AMENDMENTS TO THE DRAWINGS:

SJO9-2000-0121US1/HIT1P039

Appl.No. 09/846,707
 Amdt. Dated November 4, 2004
 Reply to Office action of October 20, 2004
 Replacement Sheet

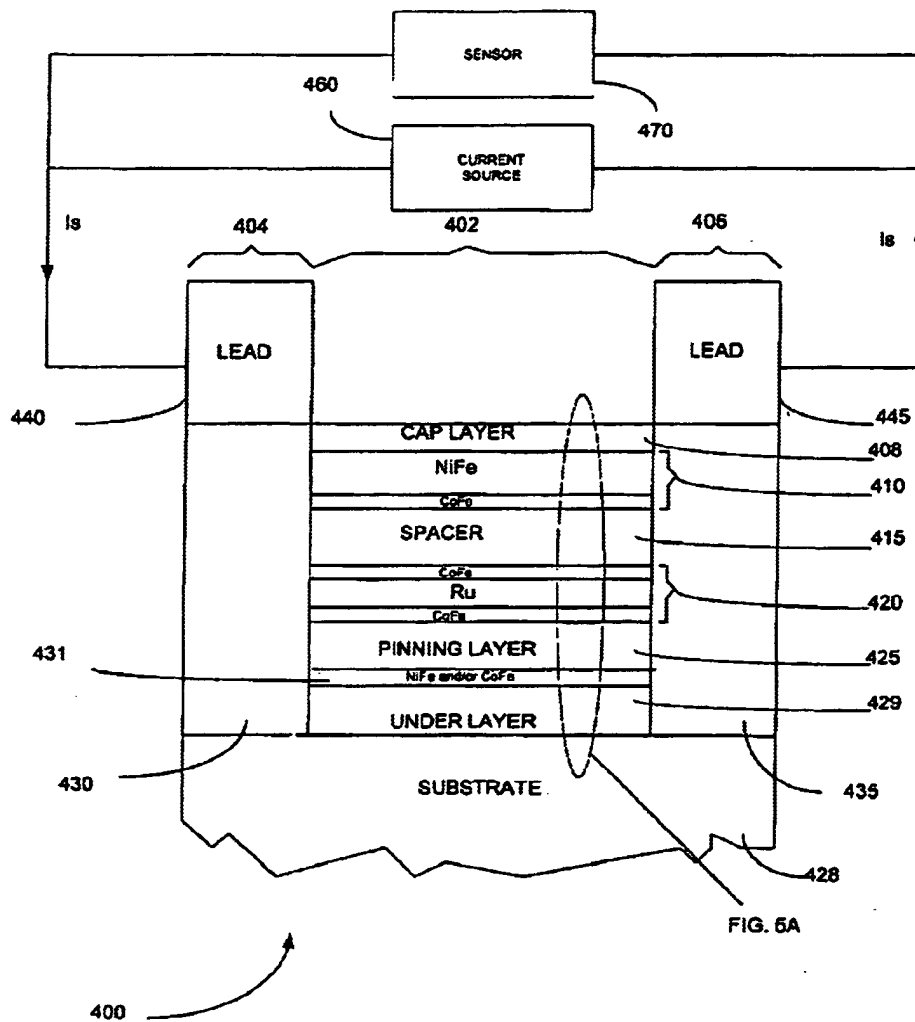
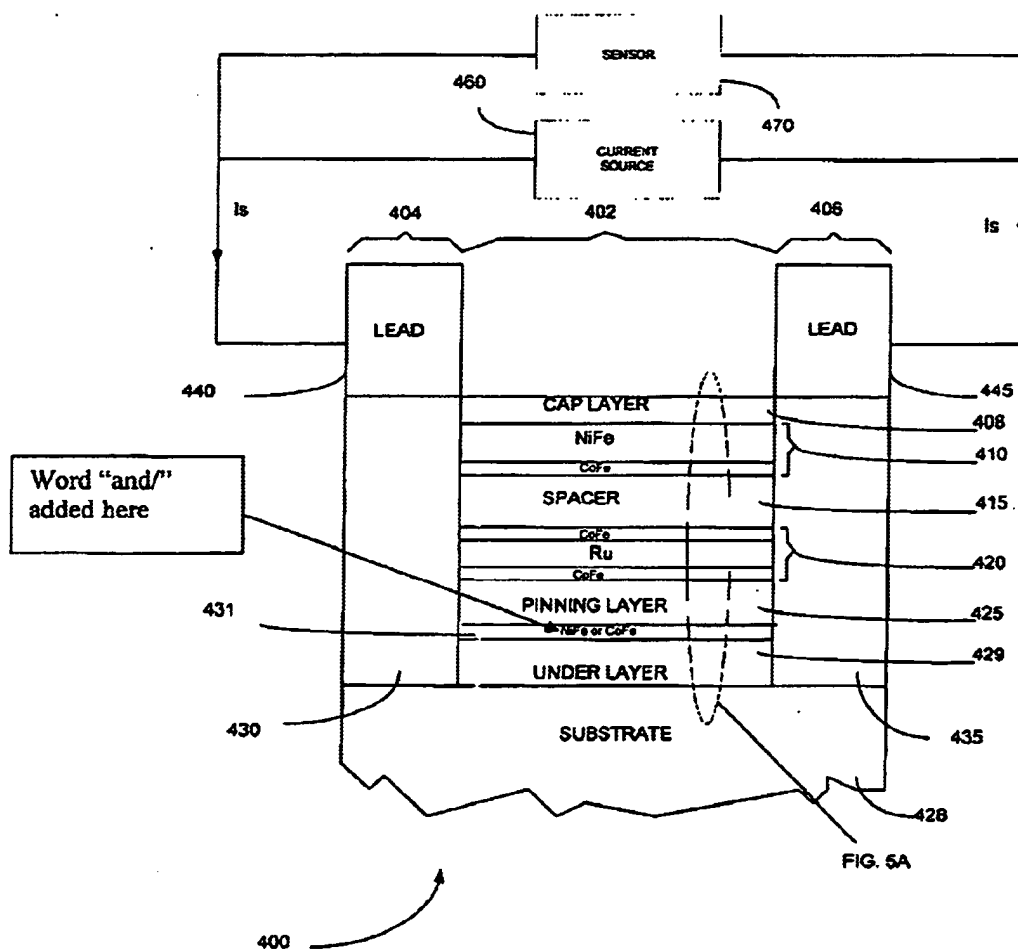
The Examiner has objected to the drawings for failing to show the claimed feature that the upper layer include NiFe and CoFe. The attached sheets of drawings includes changes to Figs. 4 and 5A. These sheets, which include Figs. 4 and 5A, replace the original sheets including Figs. 4 and 5A. In Fig. 4, the upper layer 431 is shown to include NiFe and/or CoFe. In Fig. 5A, the upper layer 508 is shown to include NiFe and/or CoFe.
